ADDRESS: 4370 GLENDALE

APPLICATION NO: #22-8170

HISTORIC DISTRICT: RUSSELL WOODS-SULLIVAN

SCOPE: REHABILITATE HOUSE (WORK COMPLETED WITHOUT APPROVAL)

4370 Glendale, Google Streetview image dating from 2009, prior to the unapproved installation of vinyl siding and the current unapproved work

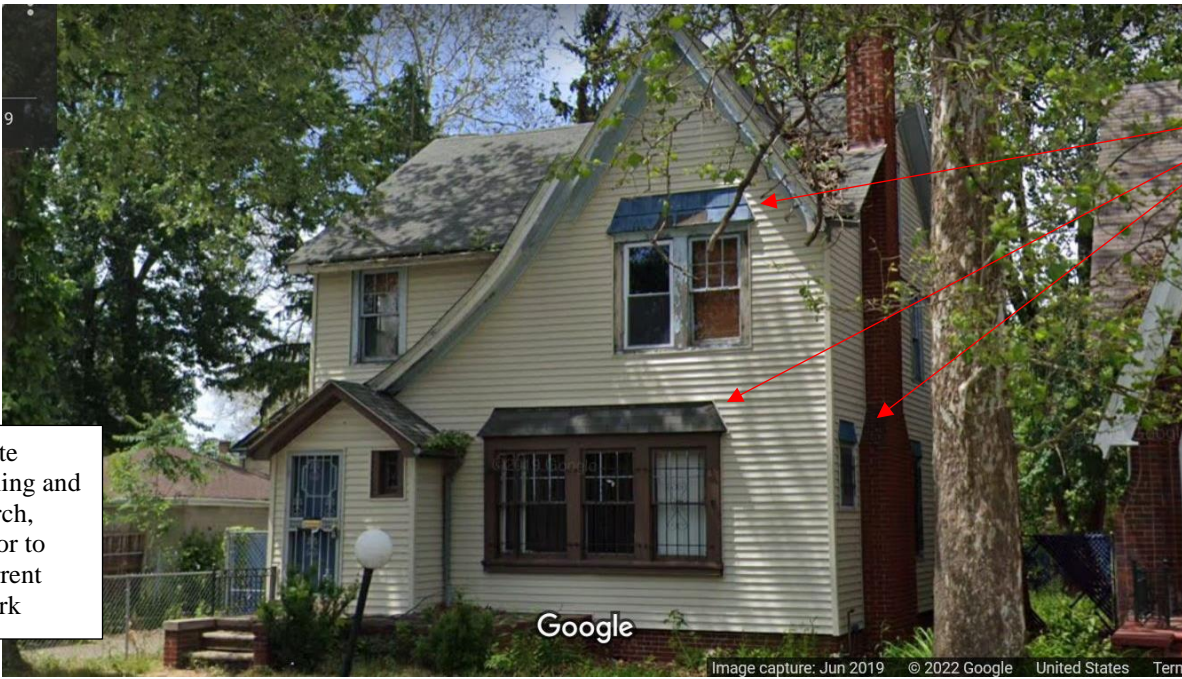
Note railing and porch, prior to current work

Note window overhangs, prior to current work

- Please see the above Google Streetview Image from 2019 and note that the original front porch included concrete steps with brick wingwalls and a 36”-high metal handrail. It is staff’s opinion that this porch was a distinctive character defining feature of the home. The current porch does not provide an adequate replication of the original due to the new higher handrails, the lack of brick wingwalls, and the application of the grey paint to the brick. It also appears that the footprint of the new porch may be larger than the original. For these reasons, staff does not recommend that the Commission approve the current front porch.

- It is staff's opinion that the windows which were replaced were distinctive character defining features of the home. Also, the former window overhangs at the front and side elevations were a significant design element. Finally, the current vinyl windows and the aluminum coilstock trim detract from the building's historic character. For these reasons, staff does not recommend that the Commission approve these work items.

Sanborn Map and Google Streetview images from 2019 and 2009 which show the rear two-story porch

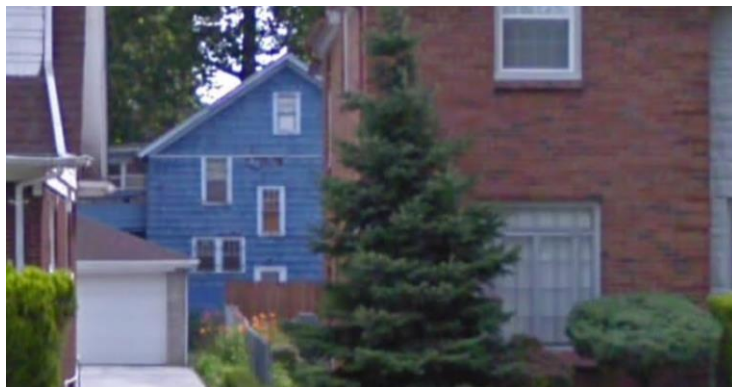
- Per the below Sanborn map, Google Streetview image, and the applicant's narrative, a two-story open porch at the rear elevation was removed as a result of the current project. The applicant states that it was removed because it was in poor condition. The two doors which lead to the porch (one at the first story and one at the second story) were enclosed and covered with vinyl. A third rear door opening at the first story was also enclosed and covered with vinyl siding. A new door opening with a set of French doors was added to the rear elevation at the first story. Finally, a gap at the fascia/soffit remains at the location of the former two-story porch roof. Note that the applicant has not provided staff with a photo of the rear elevation prior to

this work so staff was unable to ascertain the condition of the rear porch prior to its removal. As this porch was historic age, it is staff's opinion that the work as completed at the rear of the home is inappropriate.
